Access Compliance Report

Public Rights-of-Way

(Curb Ramps)

Intersection ID: 27531	Main Street: BALLANTYNE COMMONS PY	Cross Street: PLANTATION PARK BV	Location: S
ADA ID: 15493A136376	Ramp Type: Perp	Initial Pass/Fail: Fail	Overall Compliance: No
Codes/Mitigation Info/Possible Solution		Field Measurements/Component Compliance	
Severity Score: 33.75

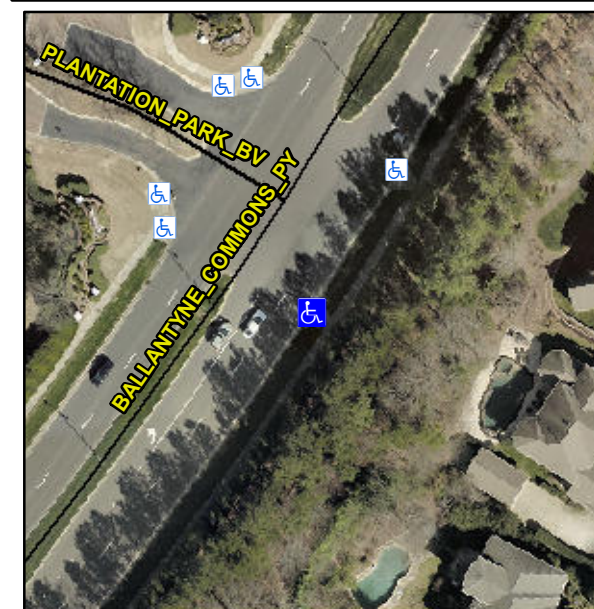
Not Found, R304.5.1, R304.5.3

Compliance	Description	Data	Compliance	Description	Data
N/A	Ramp Length (in)	120.0	Yes	Ramp Slope (%)	5.2
No	Ramp Width (in)	47.0	No	Ramp XSlope (%)	10.8
N/A	Flare Type LT	N/A	N/A	Flare Type RT	N/A
N/A	Flare Slope LT (%)	N/A	N/A	Flare Slope RT (%)	N/A
N/A	Flare Traversable LT?	N/A	N/A	Flare Traversable RT?	N/A
N/A	Landing Length (in)	N/A	N/A	DWS Provided?	N/A
N/A	Landing Width (in)	N/A	N/A	DWS Contrast?	N/A
N/A	Landing Slope (%)	N/A	N/A	DWS Length (in)	N/A
N/A	Landing X Slope (%)	N/A	N/A	DWS Full Width?	N/A
N/A	Landing Curb? (Y/N)	N/A	N/A	DWS Offset (in)	N/A
N/A	Shared Landing?	N/A			
N/A	Gutter Ponding?	N/A	N/A	Gutter Slope (%)	N/A
N/A	Gutter Lip Ht (in)	N/A	N/A	Gutter X Slope (%)	N/A
N/A	Painted X Walk1?	No	N/A	Painted X Walk2?	N/A
	X Walk 1 Direction	To NW		X Walk 2 Direction	N/A
N/A	X Walk 1 Width (in)	N/A	N/A	X Walk 2 Width (in)	N/A
	X Walk 1 Slope (%)	3.2		X Walk 2 Slope (%)	N/A
	X Walk 1 X Slope (%)	7.2		X Walk 2 X Slope (%)	N/A

Remove & Replace Entire Ramp.
